Title - Sujet Apartment Building Construction	
Solicitation No. - N° de l'invitation EW038-201920/A	Amendment No. - N° modif. 004
Client Reference No. - N° de référence du client PCA-EW038-201920	Date 2019-12-05
GETS Reference No. - N° de référence de SEAG PW-\$PWU-201-11726	
File No. - N° de dossier PWU-9-42151 (201)	CCC No./N° CCC - FMS No./N° VME
Solicitation Closes - L'invitation prend fin at - à 02:00 PM on - le 2019-12-13	Time Zone Fuseau horaire Mountain Standard Time MST
F.O.B. - F.A.B. Plant-Usine: <input type="checkbox"/> Destination: <input type="checkbox"/> Other-Autre: <input type="checkbox"/>	
Address Enquiries to: - Adresser toutes questions à: Ho (RPC), Hector	Buyer Id - Id de l'acheteur pwu201
Telephone No. - N° de téléphone (780) 901-0989 ()	FAX No. - N° de FAX (780) 497-3510
Destination - of Goods, Services, and Construction: Destination - des biens, services et construction:

JASPER STAFF HOUSING CONSTRUCTION

5 PLEX

ADDENDUM No. 3

Landscaping Plan

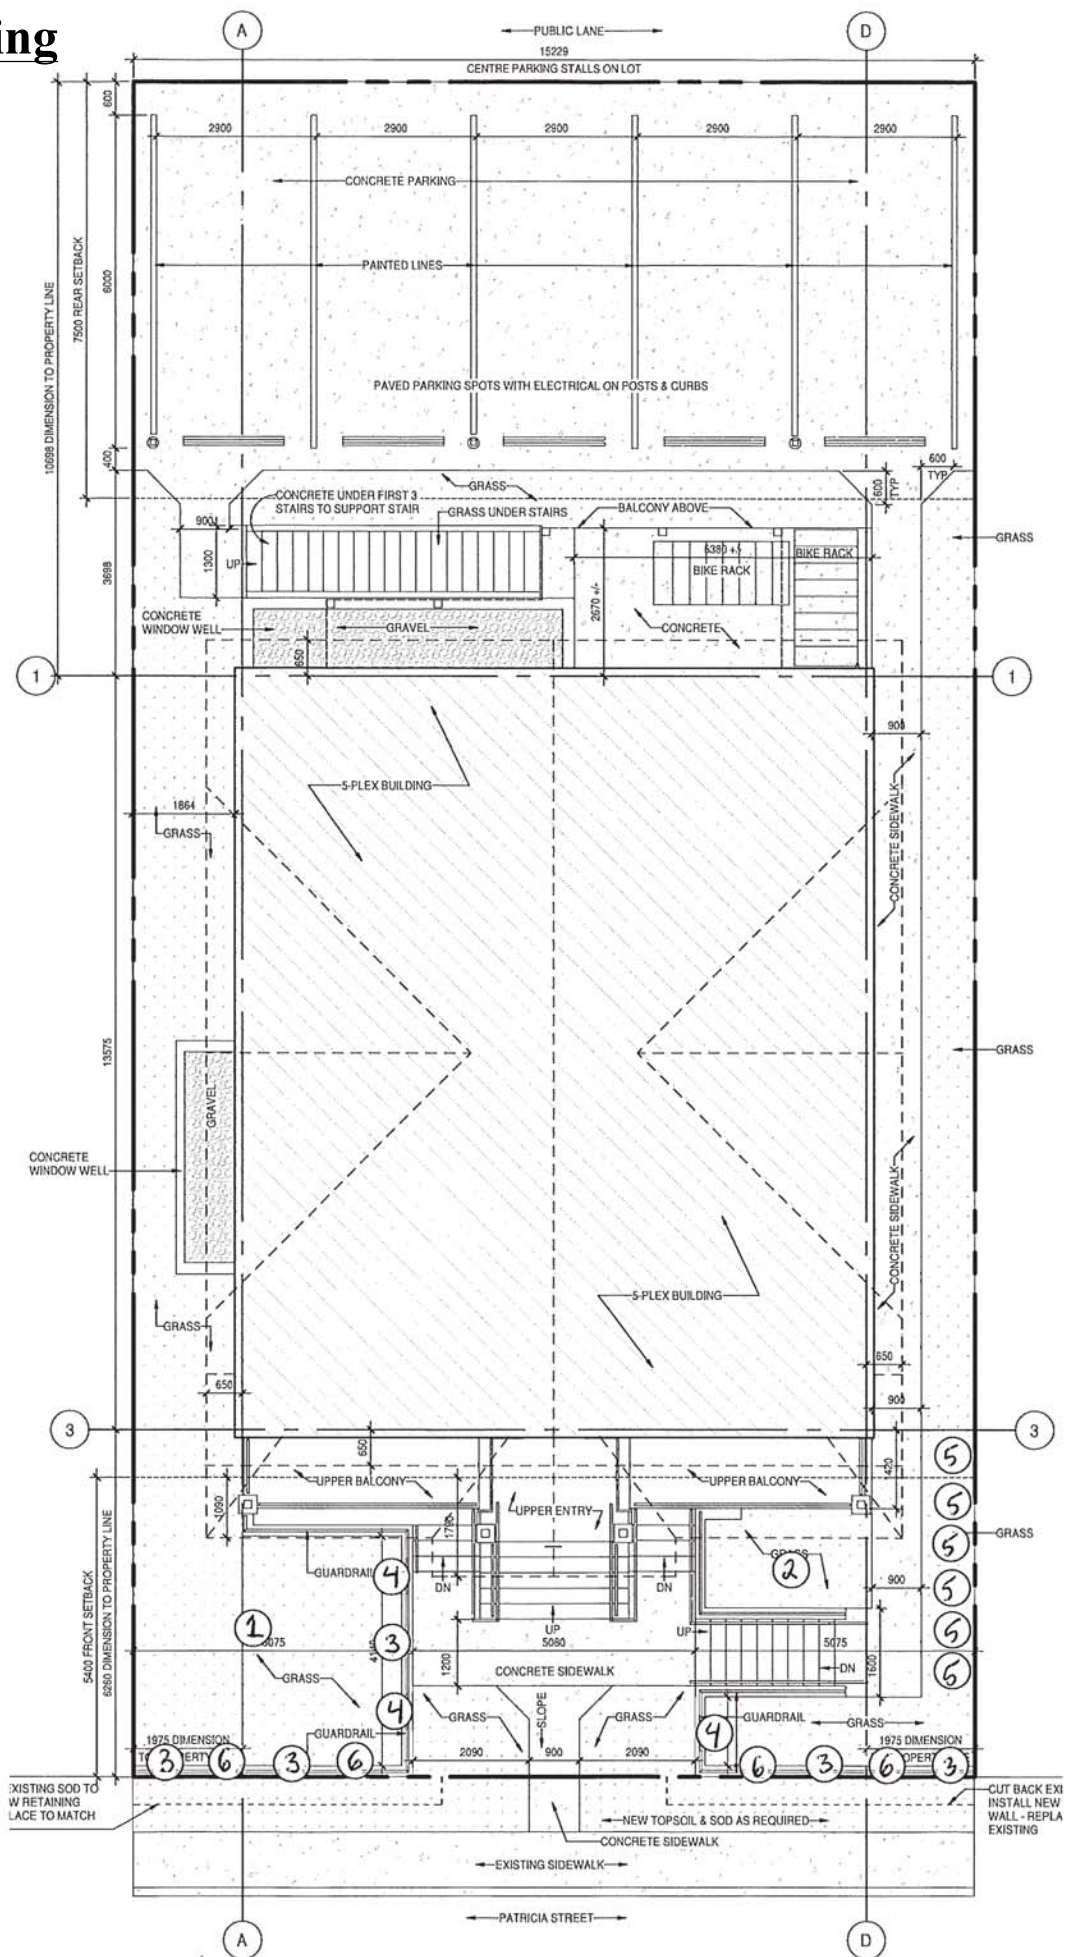
- D.** Refer to attached landscaping plan. Supply and install trees and shrubs, as identified on the plan. All grassed areas identified on Dwg A1.0 and on the Landscaping Plan are to be sod with a minimum 100mm depth of topsoil.
-
